Dutton & Jett Note Block Diagram -- AMD Brazos 2.0

PROJECT : LI2A

LI2A-AMD Schematic EC Tracking Record (Before A stage) 2011.11.10

BOARD ID SETTING (default low)

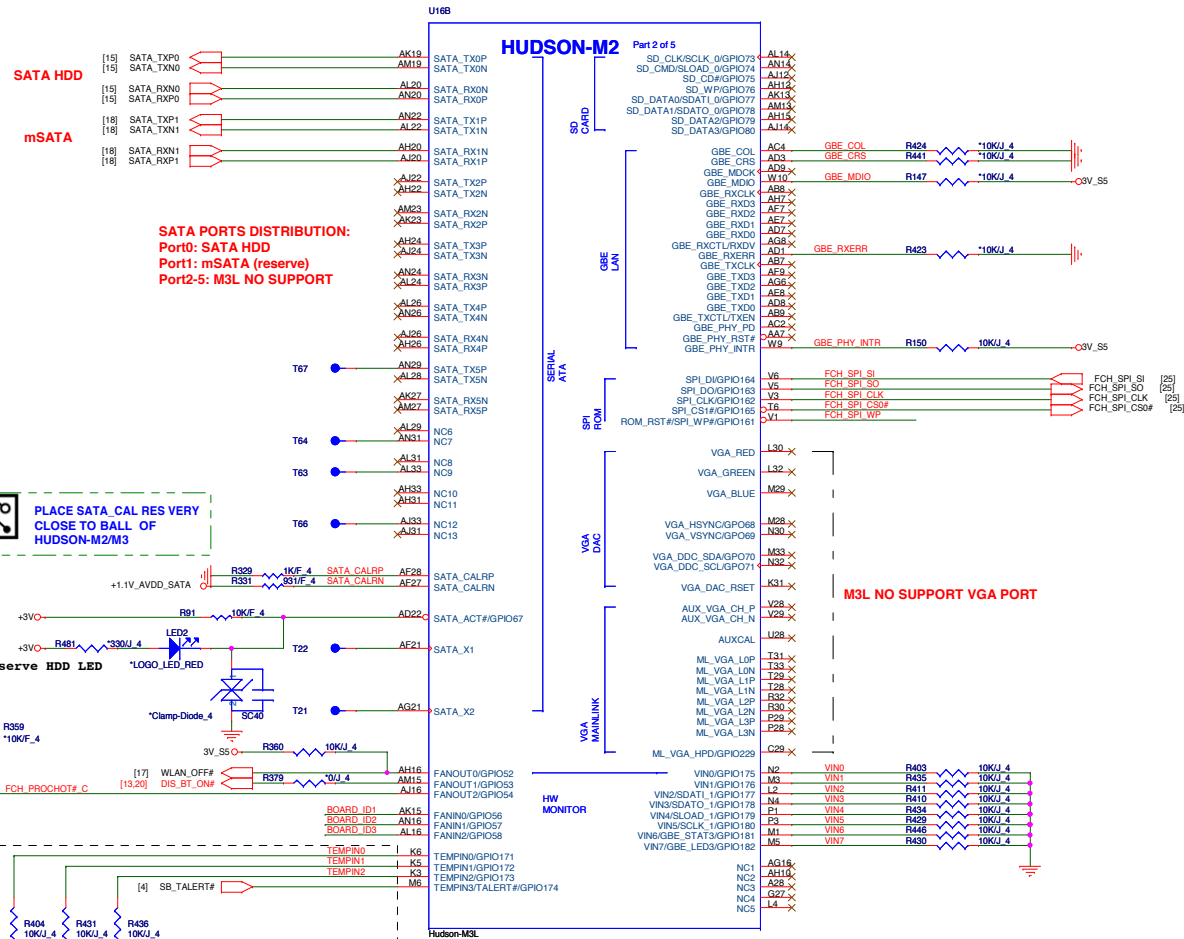
EC-A-04: EE implement HW Board ID to decide Dutton or Jett & APU.

EC-A-04: EE implement HW Board ID to decide Dutton or Jett & APU.
Add: CS31002JB28 - R381 & R369
Remove: CS31002JB28 - R383 & R371

CCD+LOGO+WLAN LED CONN

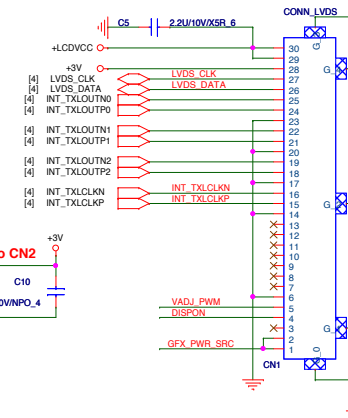
EC-A-22: EE request in order LED action error by DIS_BT

EC-C-01: Drop CCD Led relation BOM.

EC-C-10: Remove CML1 & R5 & R8 in order to place R483 & R484

EC-A-22: EE request in order LED action error by DIS_BT
Remove: BAM70020004 - Q25.

EC-C-01: Drop CCD Led relation BOM.

EC-C-10: Remove CML1 & R5 & R8 in order to place R483 & R484

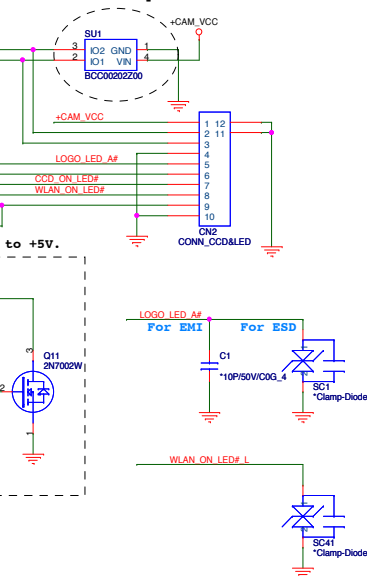
EC-A-21: ESD request.

EC-A-19: Lenovo modify LED brightness.

EC-A-19: Lenovo modify LED brightness.
Change:
from CS21002FB24 to CS11202FB11 - R1.
from CS21002FB24 to CS11502FB21 - R4.

EC-A-21: ESD request.
Add: BCC00202Z00 - SU1

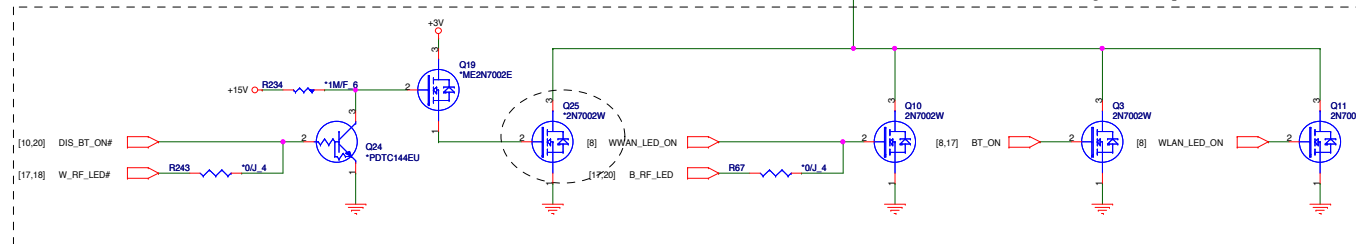
EC-C-02: Change RF Led power from +3V to +5V.

EC-23: add WWAN, WLAN, BT LED SCH to match Jett spec

EC-C-02: Change RF Led power from +3V to +5V.
Change: R1 change from CS11202FB11 to CS00002JB38
Add: R483,R484 - CS11203F918
Reserve: SC41

CAMERA VCC Control

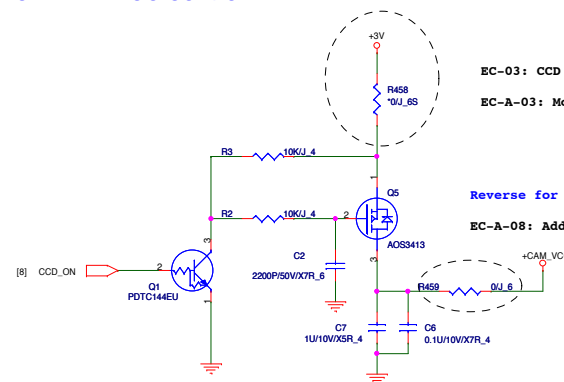
EC-03: CCD power changes from +5V to +3V

EC-A-03: Modify CCD power source width.

EC-A-03: Modify CCD power source width.
Add: CS00003J951 - R458
Remove: CS00002JB38 - R11 & *R12

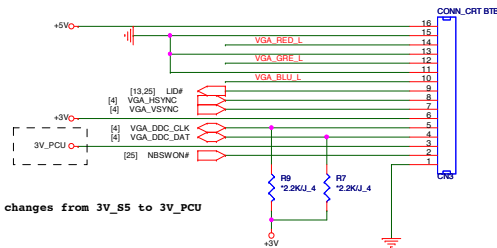
EC-A-08: Add 0 ohm to CCD power.

EC-A-08: Add 0 ohm to CCD power.
Add: CS00003J951 - R459

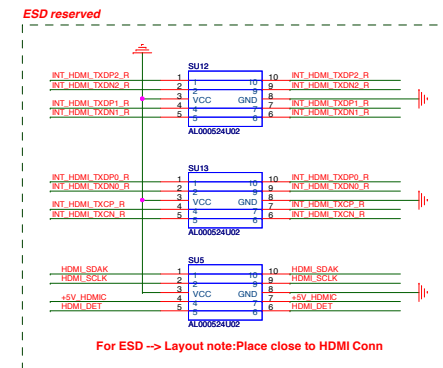
EC-19: Hall IC power changes from 3V_S5 to 3V_PCU

HDMI Level Shifter

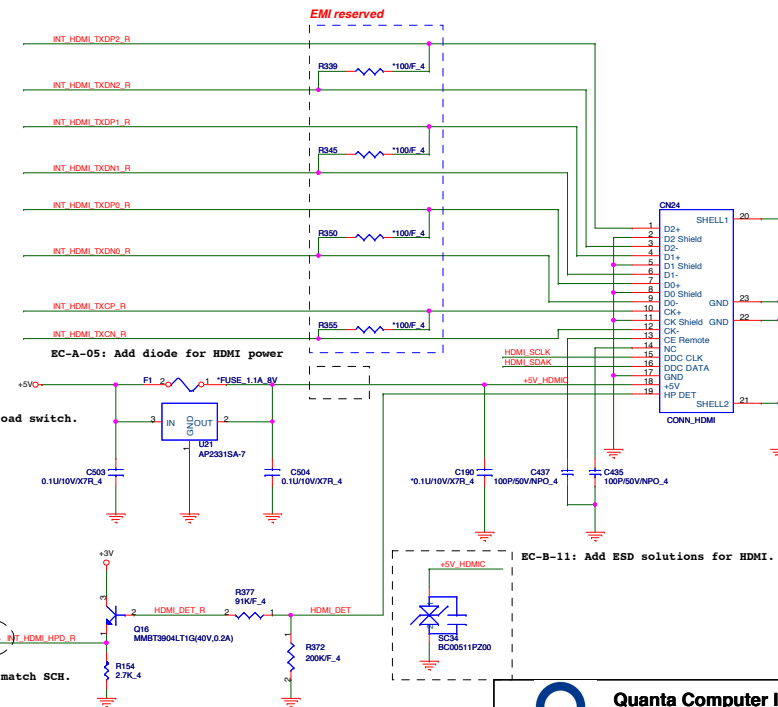
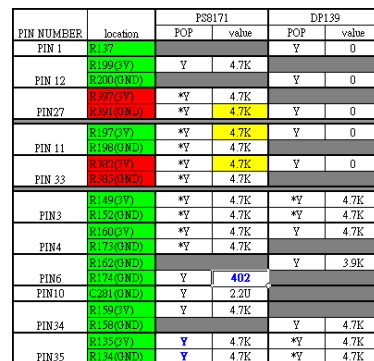
EC-02: Remove AMD HDMI related components

EC-B-07: Modify BOM to match HDMI Vendor suggestion. BOM table changed.

EC-20: Add HDMI level shifter second source BOM control table

EC-A-13: Modify BOM to match SCH.

| EC-B-11: Add ESD solutions for HDMI.

Add: BC00511PZ00 - SC34
CY4025R0B00 - SC35
CH4102K1B03 - SC36
CY000390B01 - SC37
CYAVLC15B00 - SC38

SATA HDD CONN

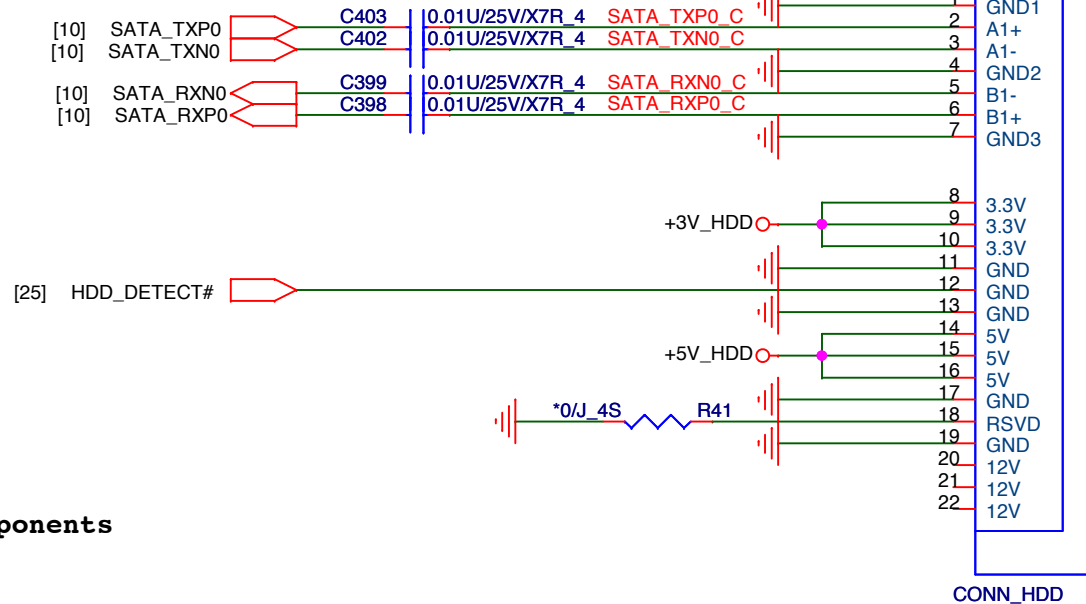
EC-01: Remove SATA redriver & other components

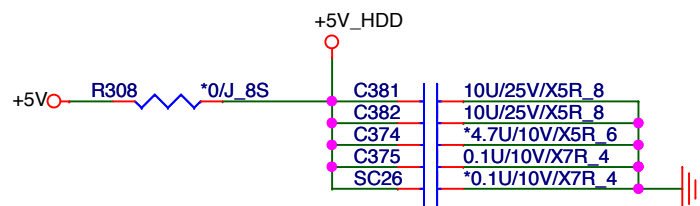
EC-16: Reserved ESD components
by ESD engineer's suggestions

USB3.0 Port0 & Port1

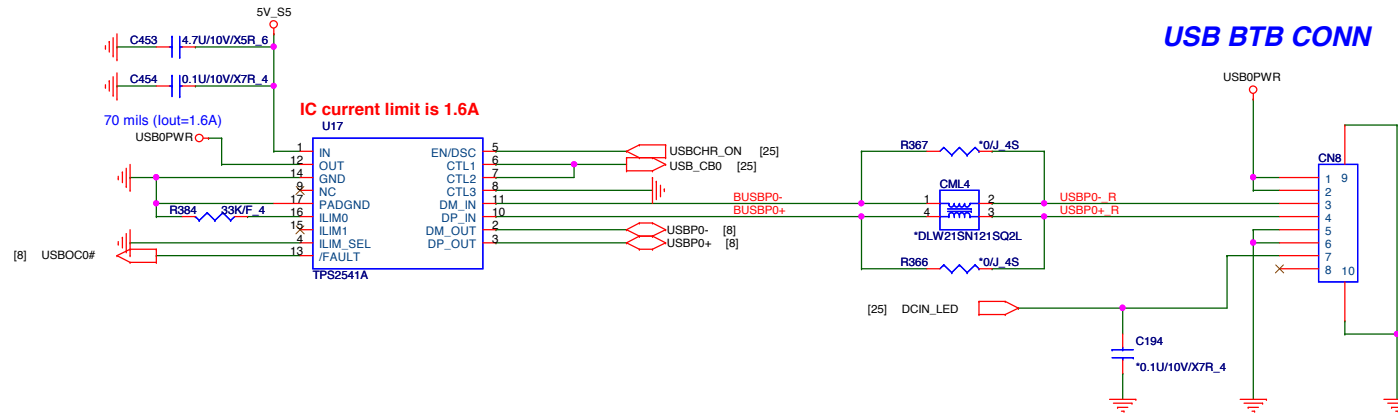
EC-07: Add ESD components by ESD engineer's suggestions

EC-B-19: ESD modify SCH & PN to pass ESD test.

Add: CYAVL5M0B00 - C499,C501
BC101304Z00 - SU7,SU8

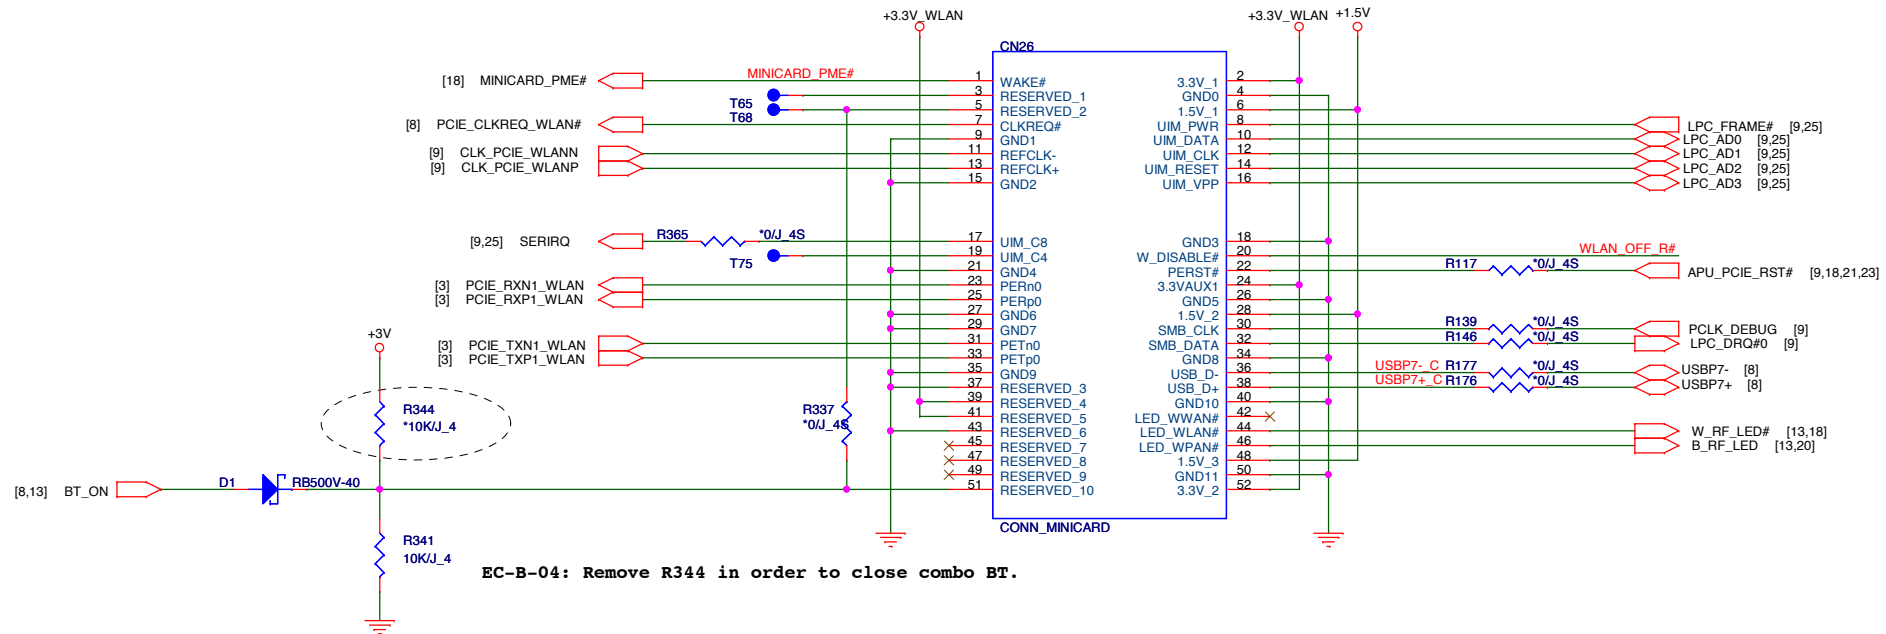
EC-B-15: Reverse ESD solutions for USB3.0.

EC-A-06: Remove AOAC SCH because AMD can not support AOAC.

EC-A-06: Remove AOAC SCH because AMD can not support AOAC.
Remove: CS00002JB38 - R167

Change: SU2,SU3 change from BCDF1004Z00 to AL000524U02

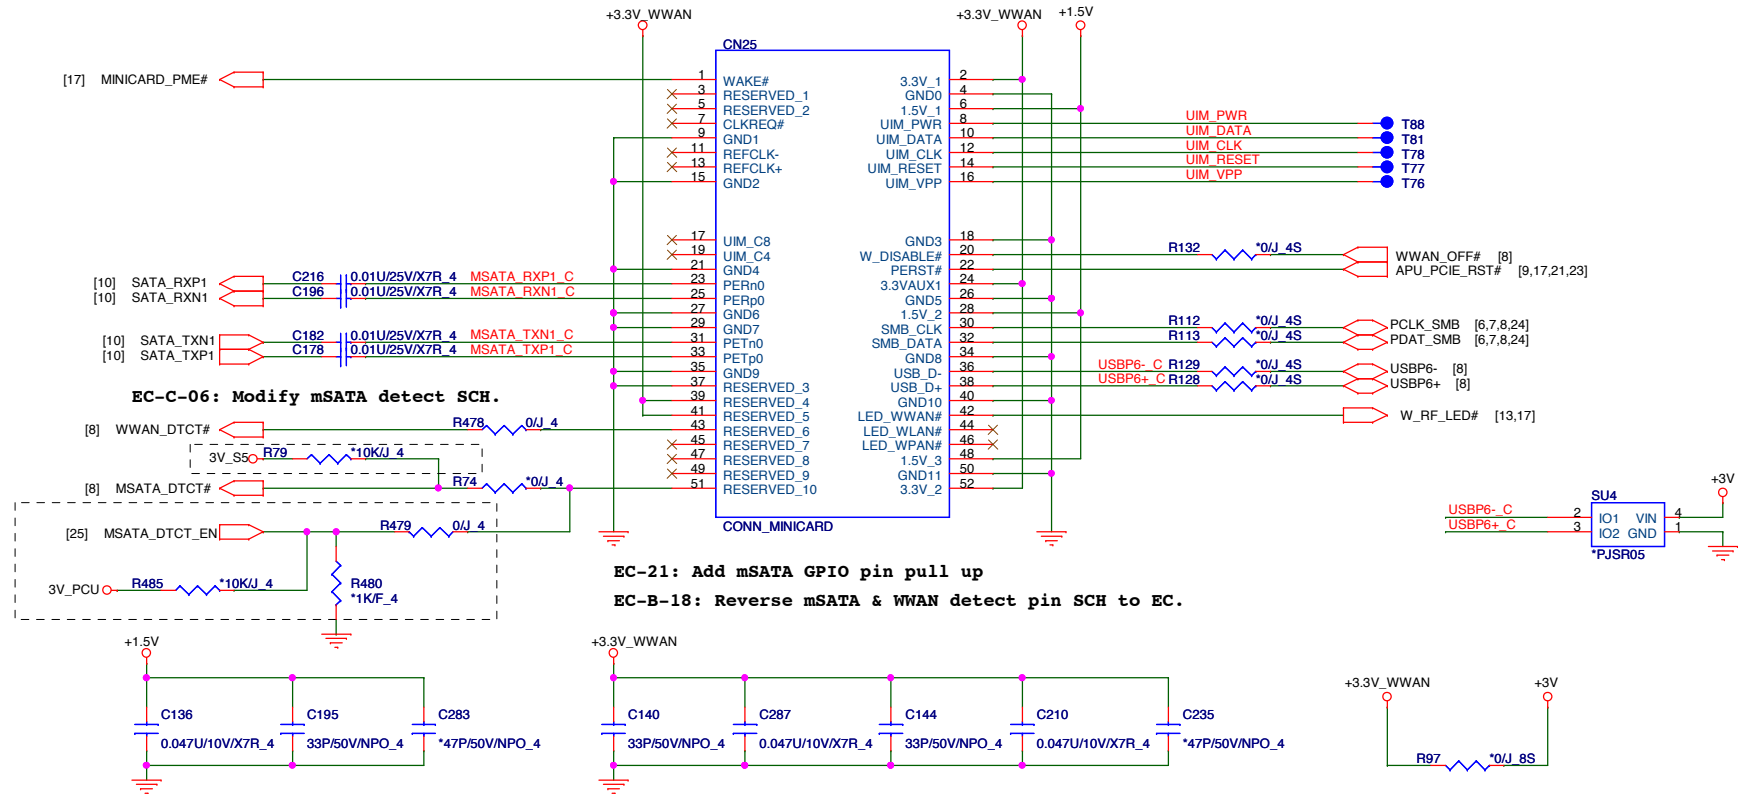
EC-B-09: Add AOAC SCH back because Lenovo request.

TOUCH PAD

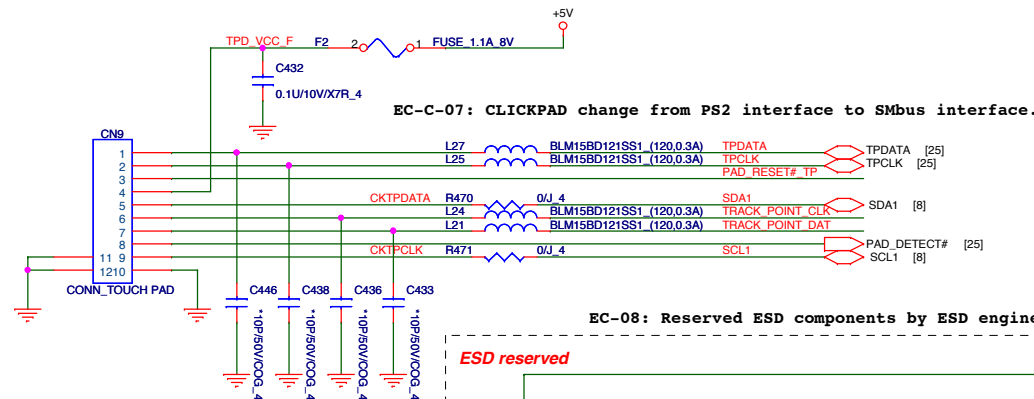
EC-B-10: Reverse Smbus CLICKPAD SCH.

Add: CS00002JB38 - R472,R473

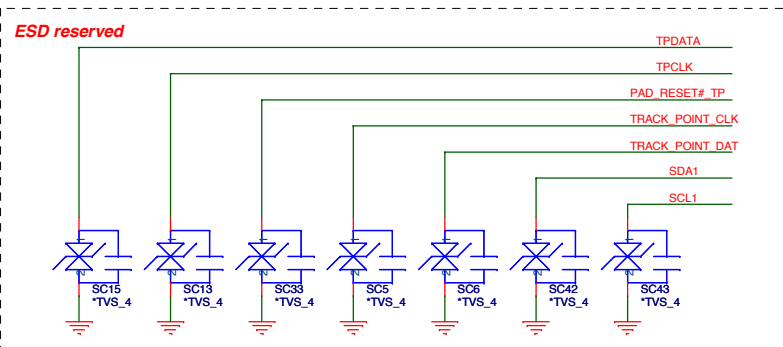
EC-08: Reserved ESD components by ESD engineer's suggestions

BLUETOOTH Reserve

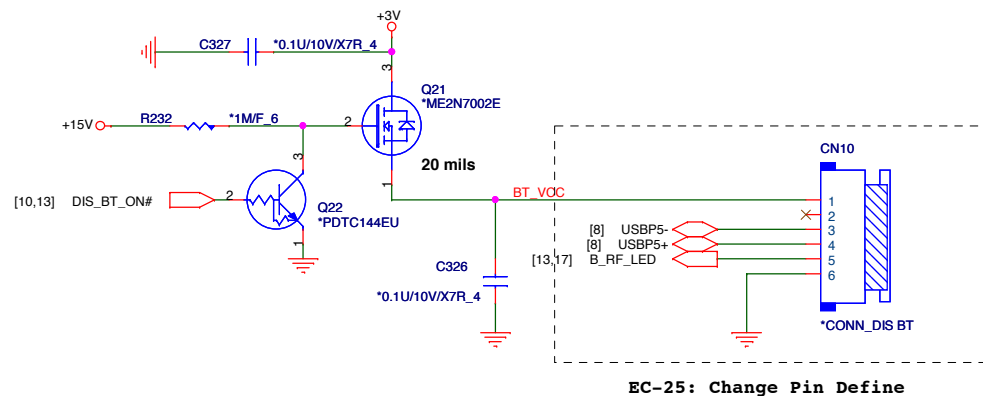
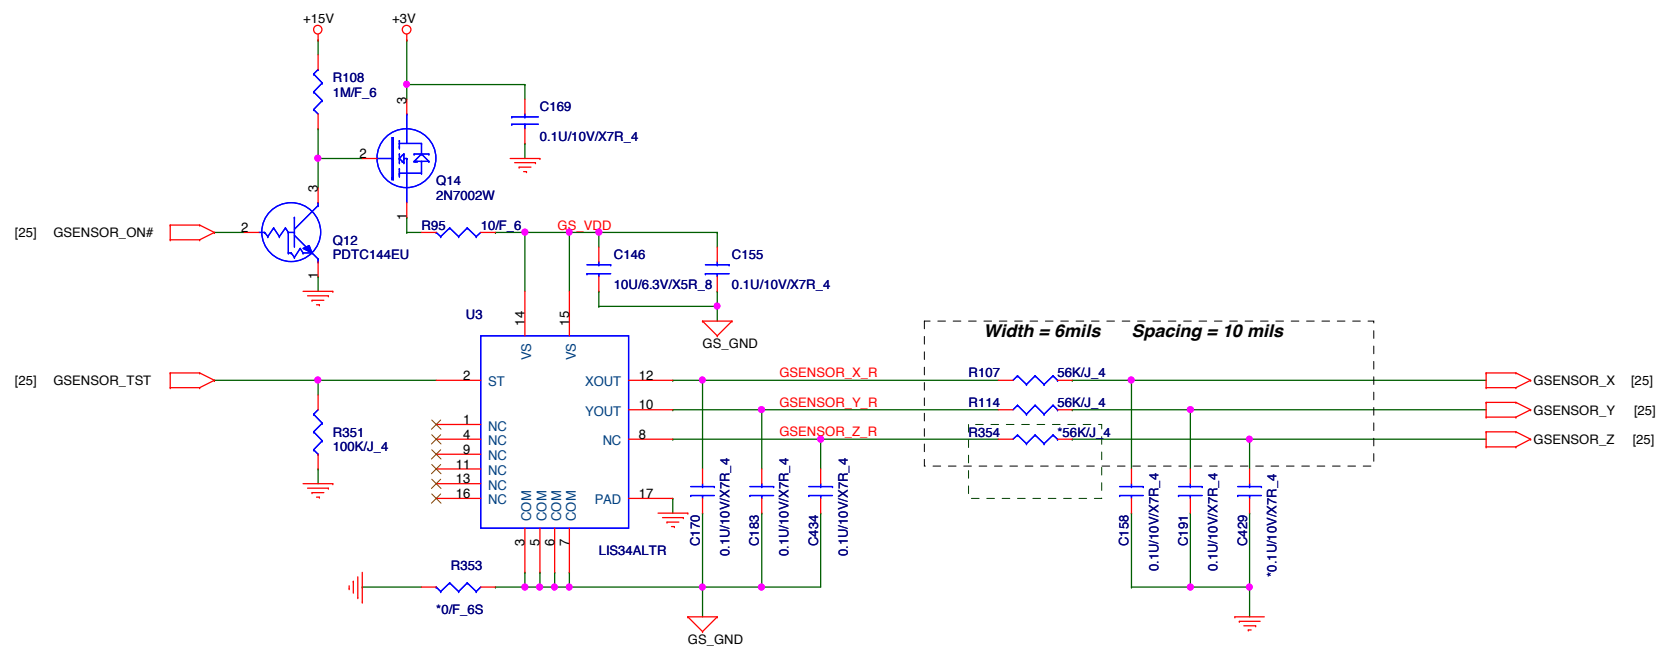
EC-B-16: Detete DIS_BT SCH.

Remove: CS00002JB38 - R379
CS51003F934 - R234,R232
CH4102K1B03 - C327
BAM700200F6 - Q19,Q21
BA001440Z87 - Q22,Q24
DFHD06MR590 - CN10

4 IN 1 CARD READER SD/SDHC/SDXC/MMC

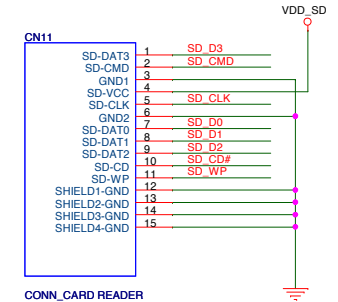
It is recommended that mismatch trace length between CLK and DATA trace is 100 mils with maximum
EC-A-18: Add 33 ohm in card reader related SCH to match vendor suggestions & EMI test.

EC-A-18: Add 33 ohm in card reader related SCH to match vendor suggestions & EMI test.
Add: CH-5606TB01 - C484
Change: from CS00002JB38 to CS03302JB29 - R449, R450, R451, R452, R453, R455.

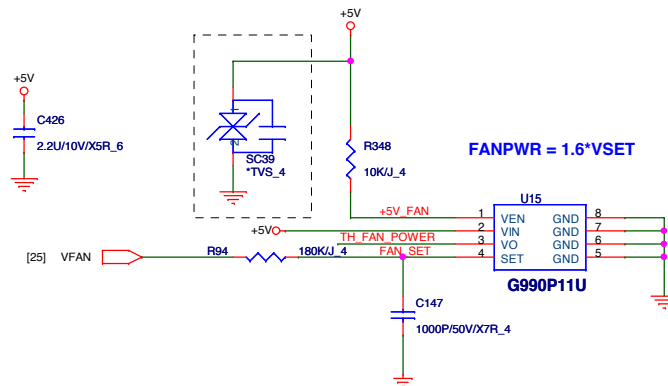
EC-B-15: Reverse ESD solutions for USB3.0.

EC-17: Reserved ESD components by ESD engineer's suggestions
